CITY OF ALBUQUERQUE

Re: Alice King Community School
8100 Mountain Rd NE
Traffic Circulation Layout
Engineer's/Architect's Stamp dated 6-27-16 (J19-D085)

A1 TRAFFIC LAYOUT PLAN
SCALE: 1" = 20' 0"

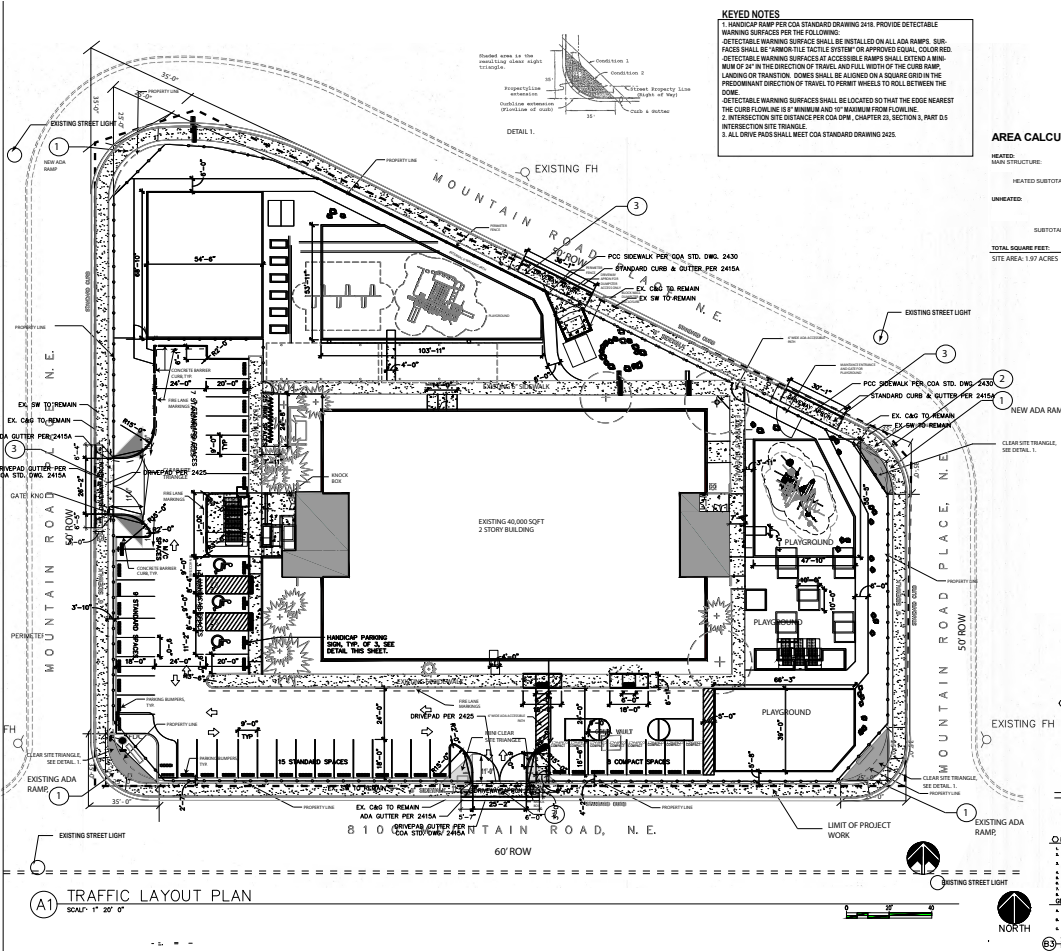
We understand that the location of the dumpster at Alice King Community School requires the trash truck to back up into Mountain Road Place, which could pose safety issues. The dumpster location is the historic dumpster location, and has been approved by Solid Waste for trash pick up. Due to site constraints which limit the ability of the trash vehicle to maneuver on site, we have no alternative but to continue to locate the dumpster at its historic location.

The TCL submittal received 7-5-16 is approved for Building Permit. A copy of the stamped and signed plan will be needed for each of the building permit plans. Please keep the original to be used for certification of the site for final C.O. for Transportation.
